ON-SITE SEWAGE DISPOSAL SYSTEM HOWARD COUNTY HEALTH DEPARTMENT BUREAU OF ENVIRONMENTAL HEALTH

SUBDIVISION: Moorefield LOT NUMBER: 3

ADDRESS: 7438 Cherry Tree Drive PROPERTY OWNER: Chris Davis

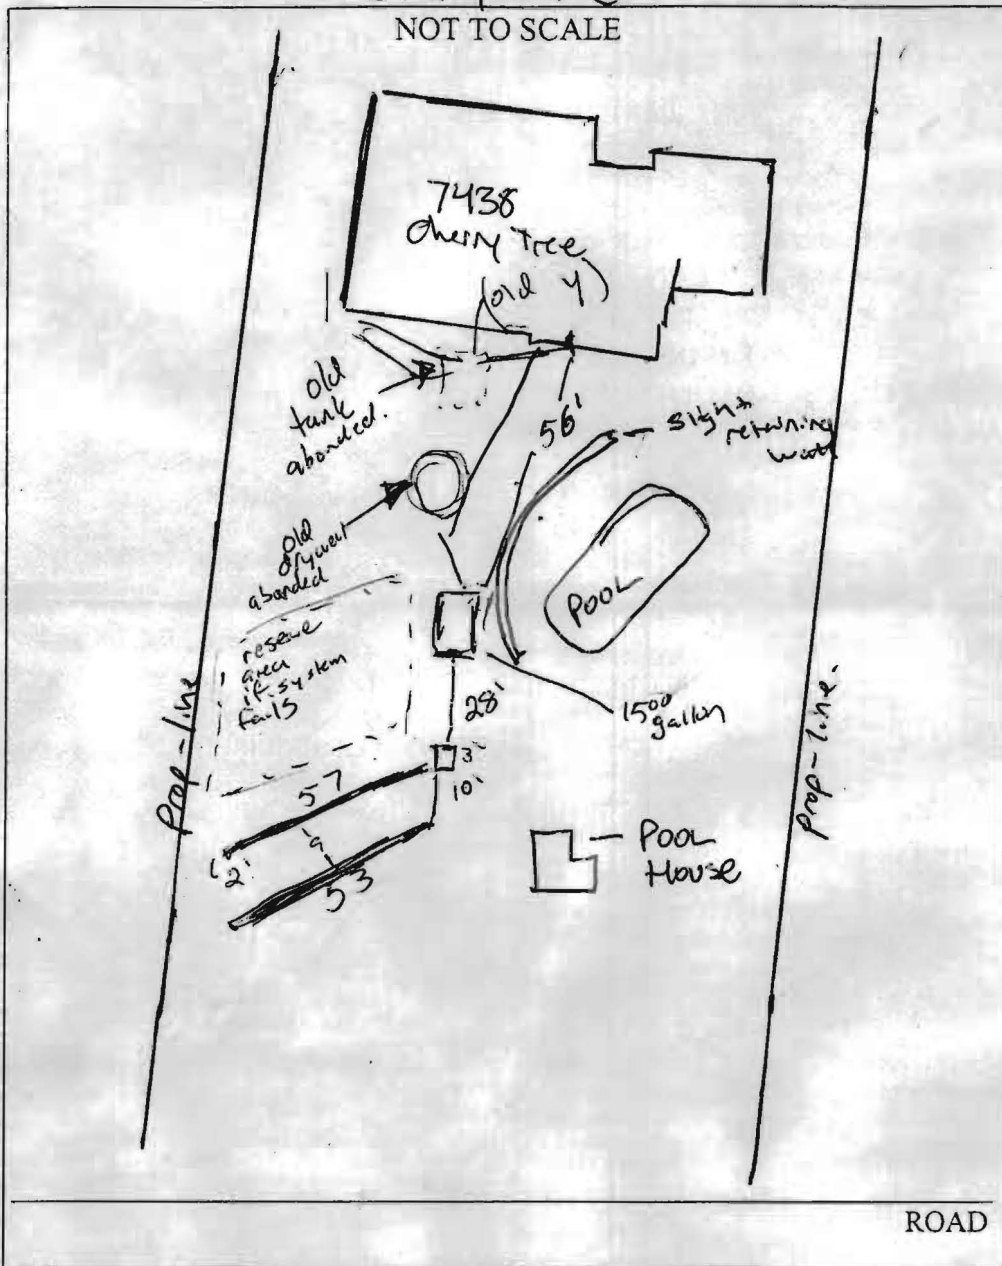
TRENCHES:	Trench to be 2.0 feet wide. Inlet ^{4.0} 6.0 feet below original grade. Bottom maximum depth ¹⁰ 12.0 feet below original grade. Effective area begins at ^{5.0} 7.0 feet below original grade. 7.0 feet of stone below distribution pipe.
LOCATION:	Layout is extremely important! Keep tank outside of the well radius, may only go no closer than 5' away from the property line with trenches.
NOTES:	Make sure there are no 90' elbows before septic tank. Make sure septic tank and trenches are 20' away from pool. Cleanout needed on d-box.

INSTALLATION 2 50' trenches - moved bottom to 10' due to

using bottom porable area, tree & patio will go in

future - (repair area) O.K. to cover trenches

with 10' extra feet added. Future repair may need. Original drywell
60" deep hose connection to be called in once completed.

AS builds to septic tank to be turned in. 10/12/05 PAM Approval

pending asbuilts of lines running to tank.
